DR 71-16 - AIRPARK SUBDIVISION
ANDOVER

Re: Airpark Subdivision - Andover

I refer to Mr. Robert A. Lakin's letter of April 8, 1971 concerning the proposed airpark in the Andover area. I submit the following information regarding its effect on McConnell Air Force Base as well as some factors that may be of interest to potential residents of an airpark.

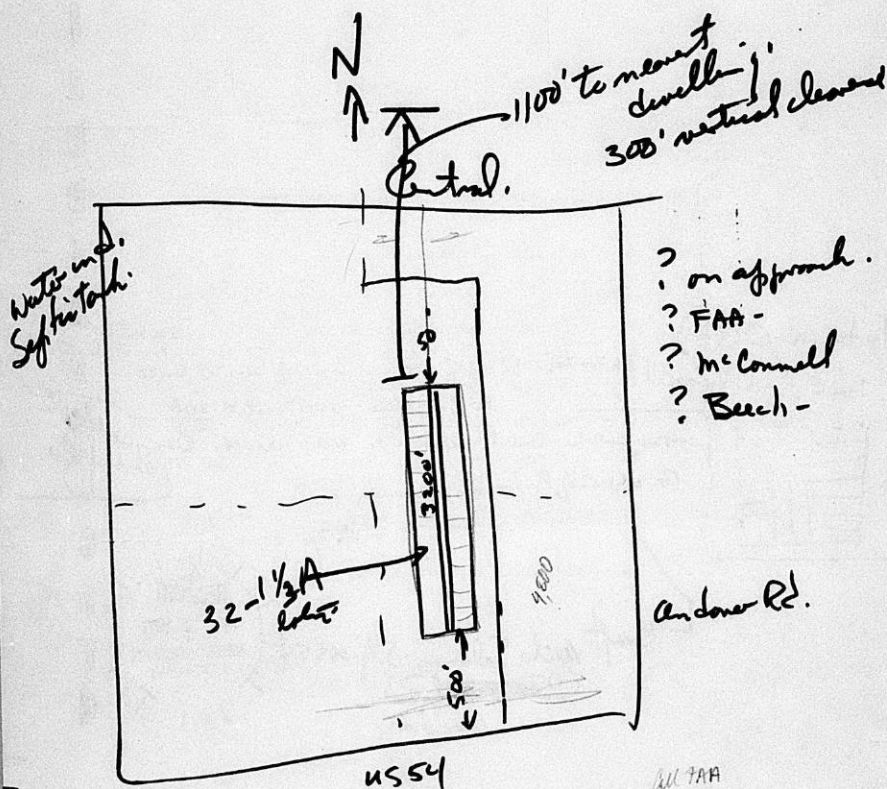
Descent to 3,000 ^{msl} here

(1,700' AGL)

VFC A Pattern downwind leg

3 to 10 miles east of McConnell AFB

at 4,000 Mean Sea Level

(2,300' above Ground level)
